Re: Review Letter #2

Russo Acquisitions, LLC
Preliminary and Final Site Plan
1000 MacArthur Boulevard
Block 135.01, Lot 65
Docket No. 620
Colliers Engineering & Design Project No. MWP-093

Figure 1: Subject site with property boundaries approximated. Source: Google Maps.

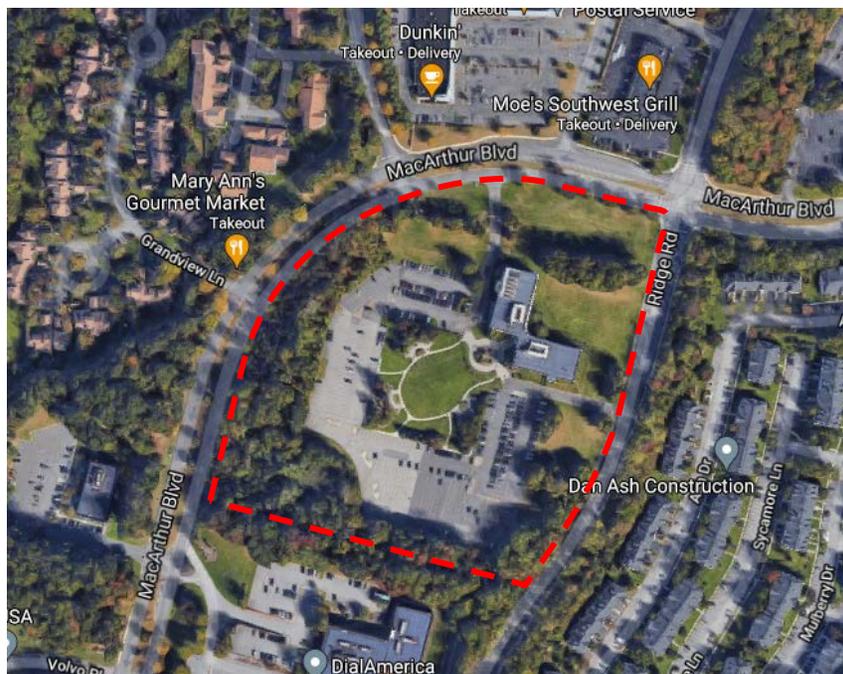
Given the unique shape of this lot, it should be noted that our review of this application is based on the following interpretation of the code for various lot and yards requirements:

- The MacArthur Boulevard frontage serves as the front lot line. This is based on the front lot line definition, which identifies the lot line separating the lot from the street right-of-way. If the lot is bounded by multiple streets or is a corner lot, the front lot line is based on the front yard designated on all maps and official record, or absent such, at the option of the owner or developer. Because the site has been identified in past applications as 1000 MacArthur Boulevard and continues to be addressed as such, our interpretation is that this frontage serves as the front lot line.

- The definitions for rear and side lot line do not specify what to do in the event of a corner lot or triangular-shaped lot. That said, as part of the definition for lot depth, the code states: “In the case of a triangular shaped lot, wherein there is no discernible rear lot line, the lot depth measurement shall be taken from the midpoint of the front lot line to the intersection of the side lot lines where that occurs most distant from the front lot line.” Considering that the subject lot is both a corner lot and a semi-triangular lot, it is our interpretation then that the southern lot line and the lot line on Ridge Road serve as side lot lines.

- The lot line along Ridge Road, while identified as a side lot line, is also considered a “side street lot line” according to the code, and as such, is subject to the front yard requirements of Chapter 24 (Zoning).
- Based on the above, our measurement of lot depth is based on the measurement from the front lot line to the intersection of side lot lines, which we have estimated to be approximately 925 feet.
- Similarly, our measurement of lot width is based on the definition in the code for lot width, where width is measured between the side lines from the required front yard setback line. As an oddly shaped lot, the code suggests that the width should also be measured at the front lot line. We have estimated that the lot width at the front lot line to be approximately 1,490 feet, and approximately 1,400 feet from the front yard setback line.

Testimony by the Applicant’s planner at the September hearing acknowledged this interpretation; therefore, plans should be revised accordingly.
